S148-07/08

Table 1804.2; IRC Table R401.4.1

Proponent: Dennis Dickard, PE, MPE, RBO, Hamilton County Building Inspections, OH

PART I – IBC STRUCTURAL

**FIGURE 1805.3.1
 FOUNDATION CLEARANCES FROM SLOPES**

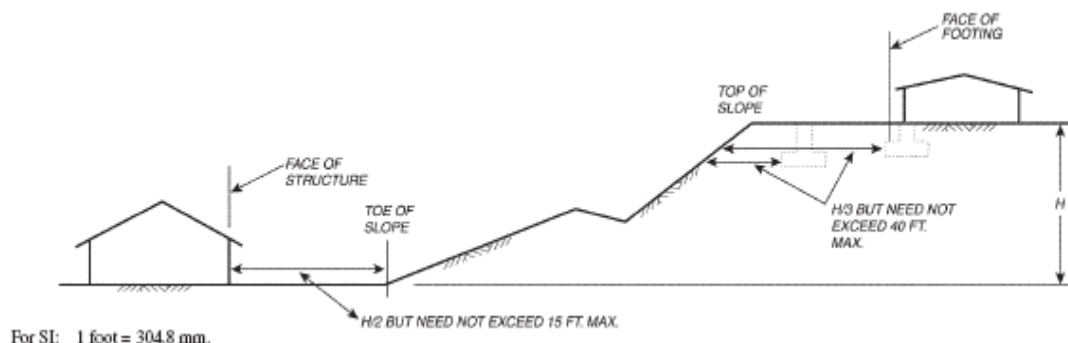
Revise figure notation as follows:

AT LEAST THE SMALLER OF H/2 AND BUT NEED NOT EXCEED 15 FEET FT. MAX
AT LEAST THE SMALLER OF H/3 AND BUT NEED NOT EXCEED 40 FEET FT. MAX

Reason: Code clarification. Editorial.
